PLANNING COMMISSION

AGENDA

**PLANNING COMMISSION
STAFF EVALUATION
FIRST REVIEW**

PLANNING COMMISSION MEETING: February 13, 2025
PLANNING COMMISSION ROLE: Recommending Body to City Council
APPLICATION TYPE: Site Plan Approval

WILCOX LANDSCAPE / LANDSCAPE YARD / RV STORAGE
 CONCEPTS / CONSTRUCTION
 Planning Concepts

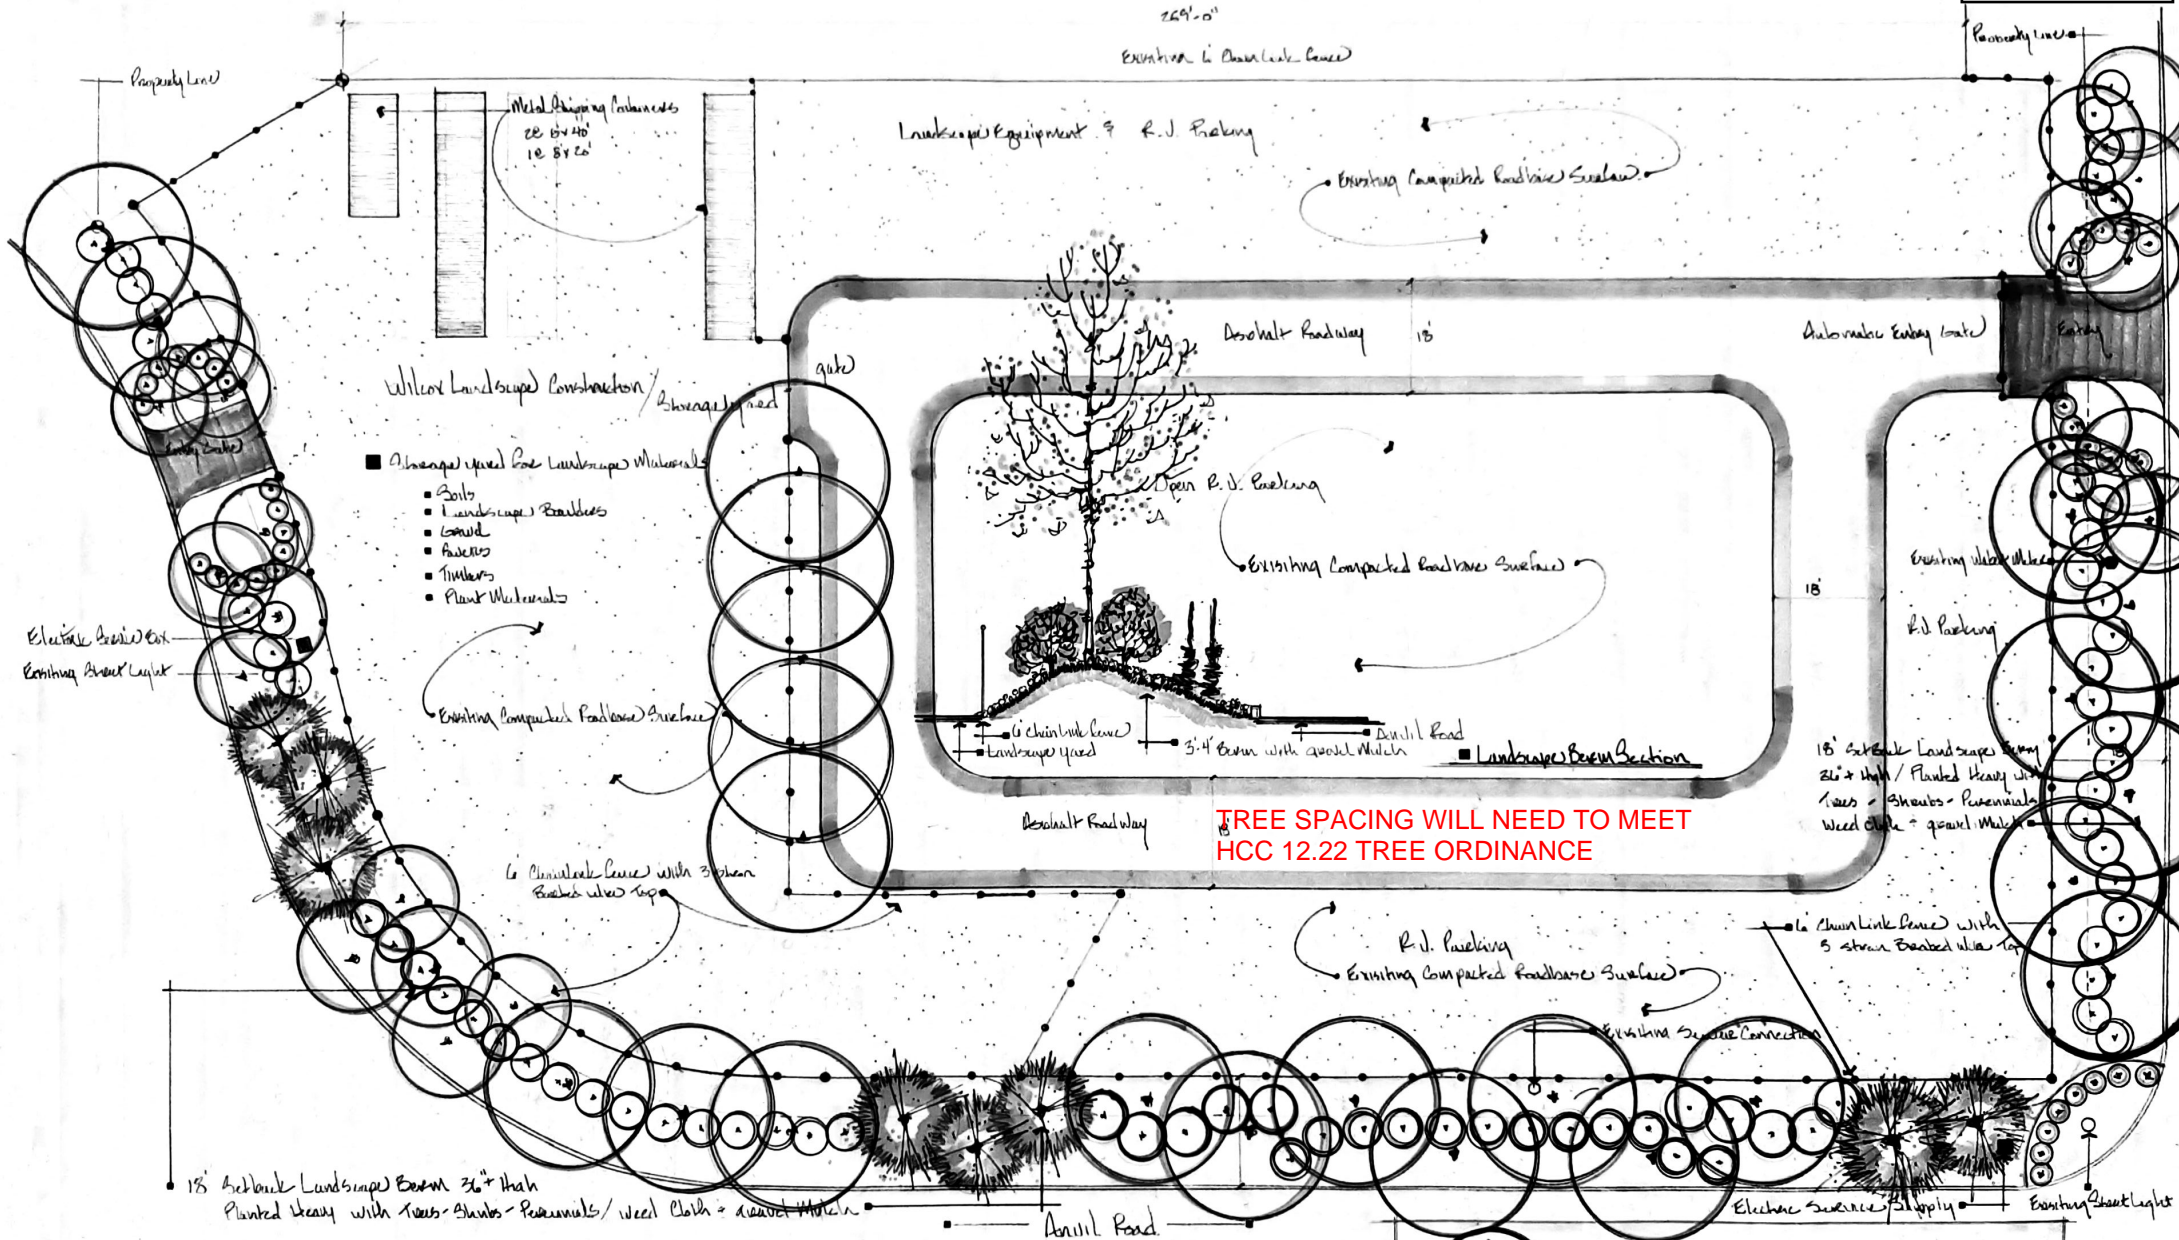
1. The new 2,240 sq. ft. pole barn building will require a building permit.
2. There is a landscape berm around the property that is located inside a 10.00' public utility easement that was requested to be modified during the original site plan approval to reflect utility access. Staff has concerns that the berms has not been modified to reflect or improve access.
3. The following original site plan improvements are not complete:
 - a. The public right of way landscaping adjacent to the public street is not complete.
 - b. The east and west side driveway accesses are not paved.
 - c. The interior asphalt roadway on site is not complete.
4. Staff recommends the applicant contact Hyrum City Business Licensing to determine if the landscape and materials yard operations requires a Business License.

1. Staff would like to see the berm on the property moved back out of the utility right of way to ensure adequate access to utilities.
2. Staff would also like to see permanent vegetation on the berm such as a buffalo grass and or cabin mix to help with erosion control and would add good aesthetics to the property as well as easier maintenance.

PARKING AT OFFICE AREA SHOULD BE PAVED

SECURITY LIGHTING SHOULD BE ADDED TO SITE.

SLATS SHOULD BE INCLUDED ALONG FENCE TO PROVIDE SCREENING.

PROPOSED SITE LAYOUT

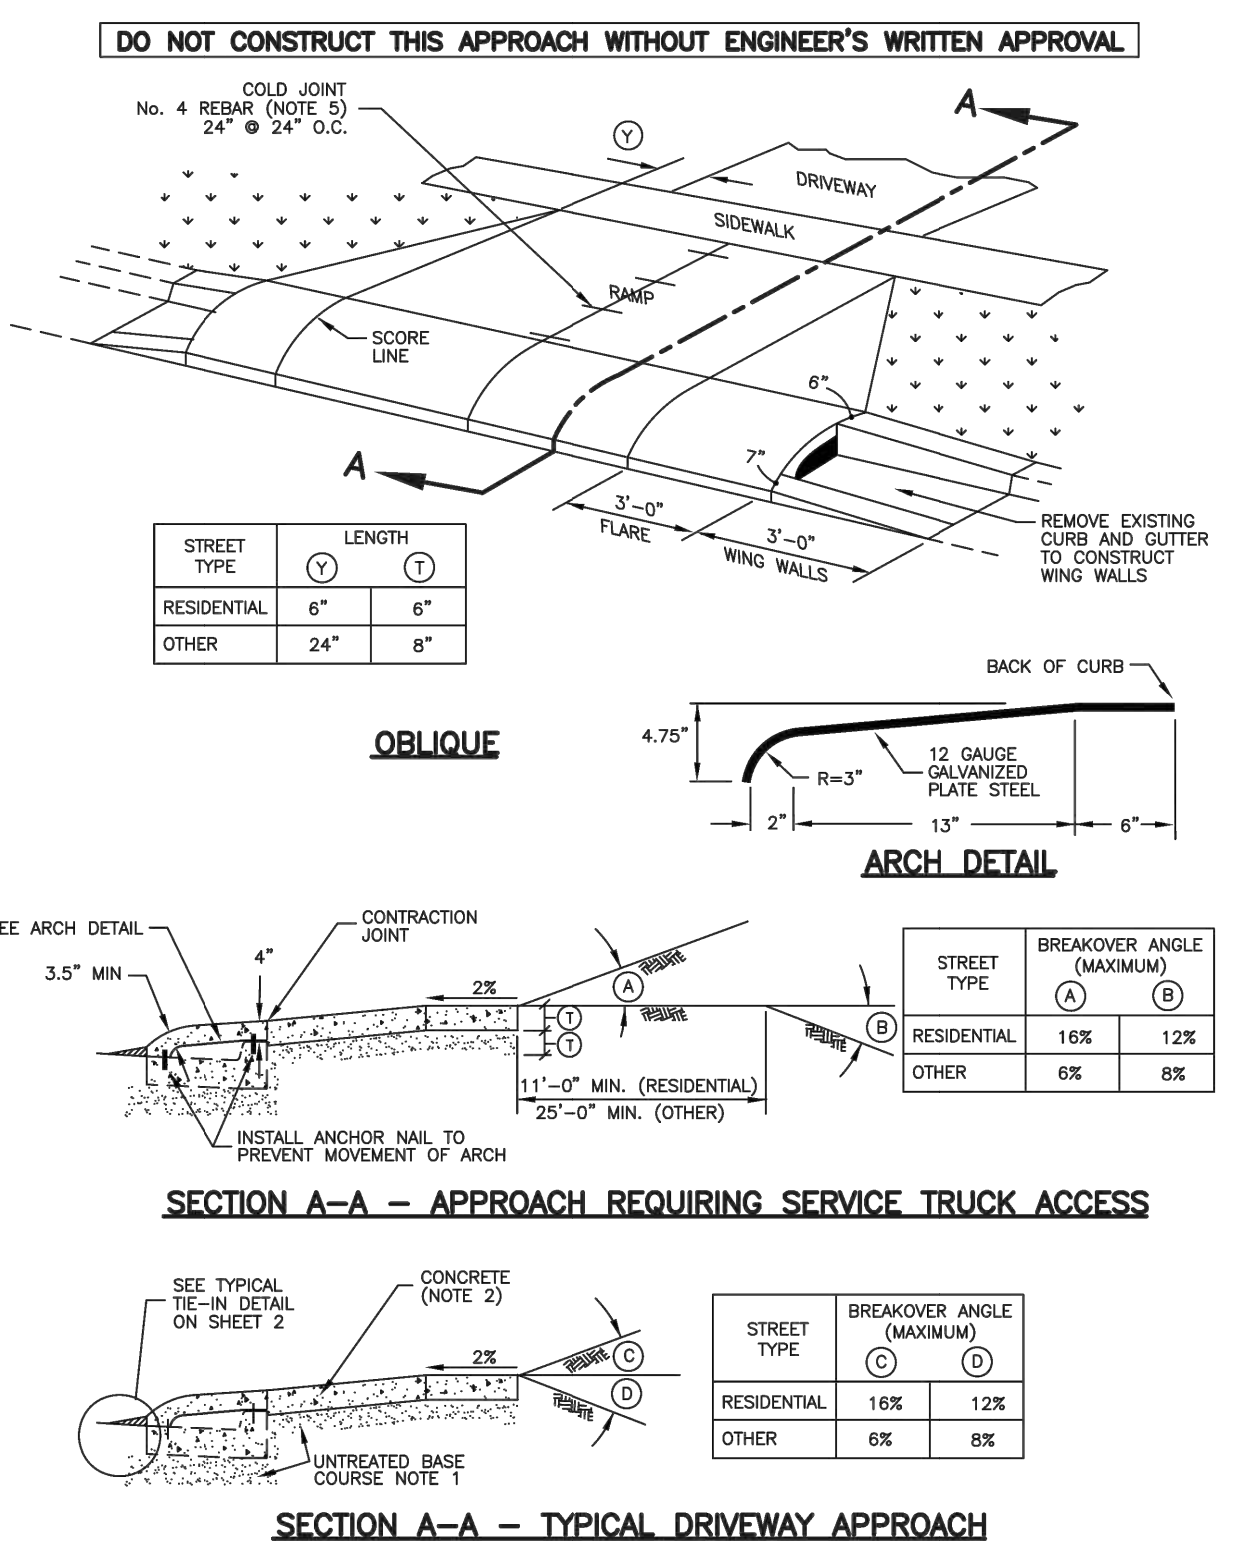
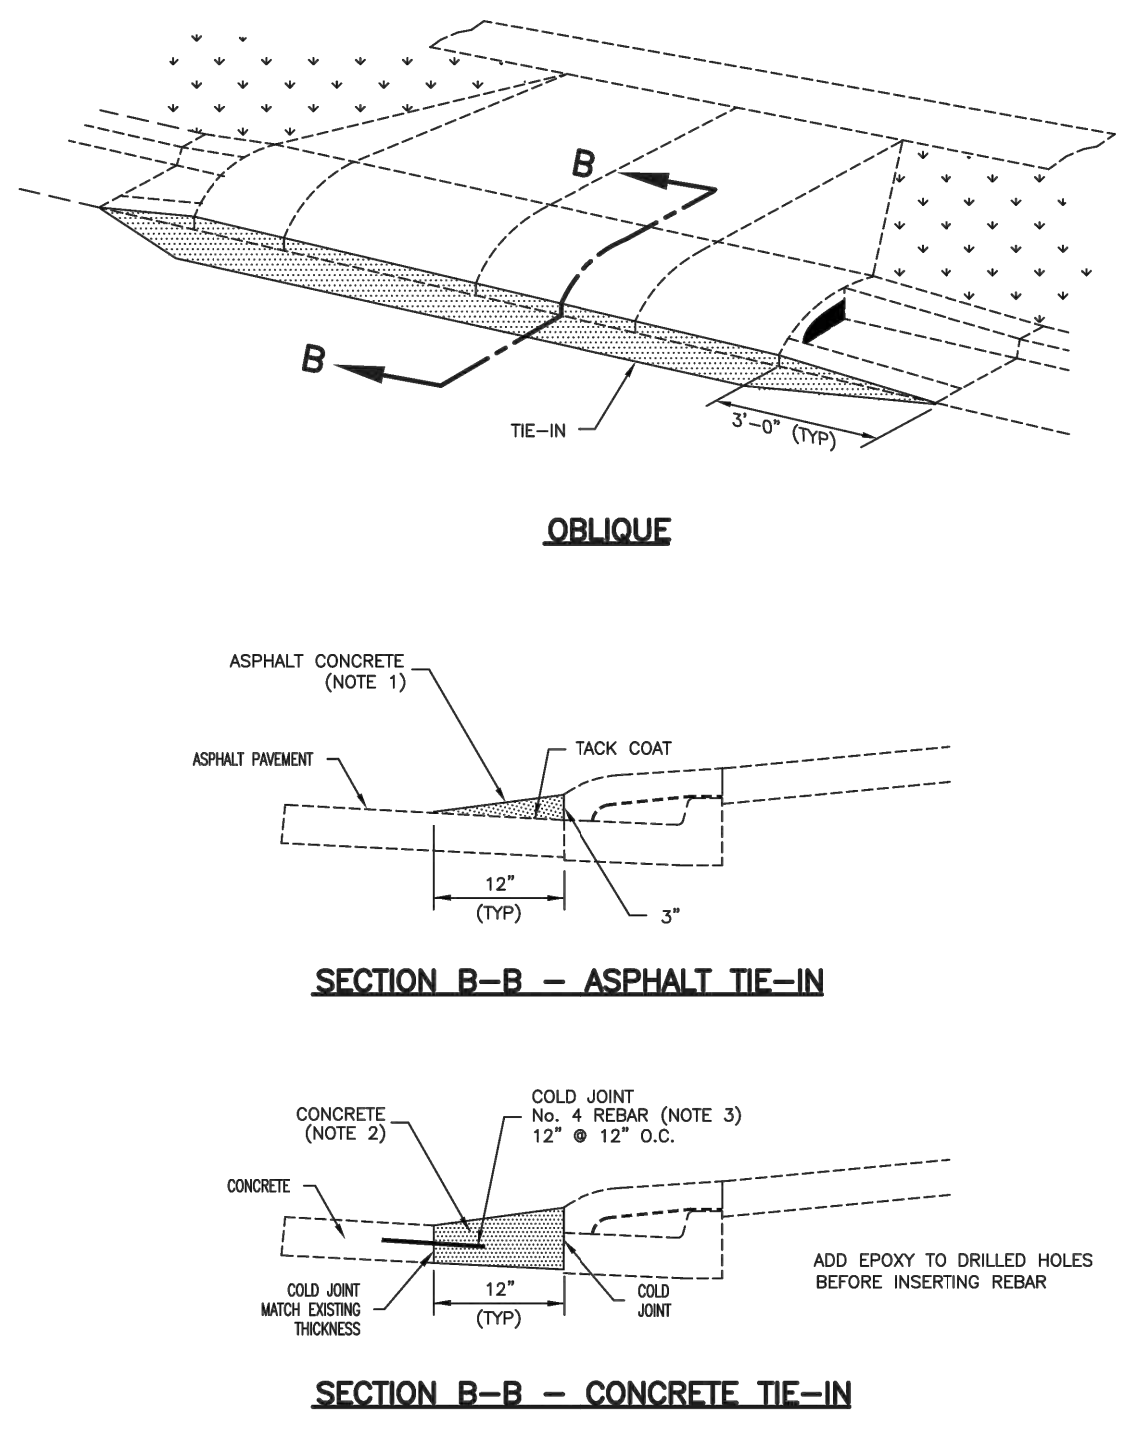
1. Staff supports a Mixed Use of Commercial and Hotel as permitted in HCC 17.45.020 Use Regulations.
2. Staff did not receive the required Lighting Plan submittal. HCC 17.45.120 requires that each site plan shall include a lighting plan.

3. Staff does not support the west building crossing the east property line of property parcel: 01-050-0023 as proposed on the site plan and recommends combining the two property parcels. HCC 17.45.050 Yard Regulations – Commercial Use may permit a zero-yard setback at a property line at a qualifying location; however, it does not qualify a building to encroach beyond a property parcel. If the applicant desires to relocate the said building to a conforming location on the parcel, Staff will request the following revisions to the site plan:

- b. Cross access agreements need to be prepared and recorded to each property parcel for UDOT driveway approach interior parking.
4. The site plan proposes parking stalls to be a minimum of eight (8) feet in width and does not identify the proposed parking stall depth. In the C-2 Zone, HCC 17.45.210.C. Off-Street Parking – Special Requirements requires the site plan to provide nine (9) feet by twenty (20) feet parking stalls.

5. The applicant did not submit a total parking stall count on the site plan. Staff supports the required parking of one (1) space per each unit, room, or guest accommodation as regulated in HCC 17.45.200 Off Street Parking – Specific Requirements which reserves a total of twelve (12) parking spaces for the Hotel Use.

6. Without the applicant providing the exact square feet of proposed commercial uses (excluding storage areas, restrooms, office areas, etc.) Staff cannot verify the required off-street parking requirements regulated in HCC 17.45.200 Off-Street Parking – Specific Requirements to conclude parking requirements.

7. The site plan shows the cedar fence terminating at the south portion of the paved parking lot. The parking lot is still facing adjoining neighbor properties. HCC 17.45.050 Yard Regulations – Commercial Use requires the fence to continue south on both east and west property line and along the south property line enclosing the development.
